Guardrail Maintenance and Replacement for the Peach County Board of Commissioners RFB 24-005 TPE NO. PCO 064-Guardrail

03 June 2024

#### ADDENDUM NUMBER NO. 1

# Site #4 – Taylors Mill Road

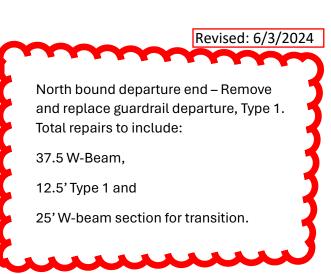
Damaged guardrail to be replaced. See picture below.

Remove & replace <u>+</u>75 damaged W-Beam system. Reset 1 additional post. Replace an additional 4 offset blocks at various locations.
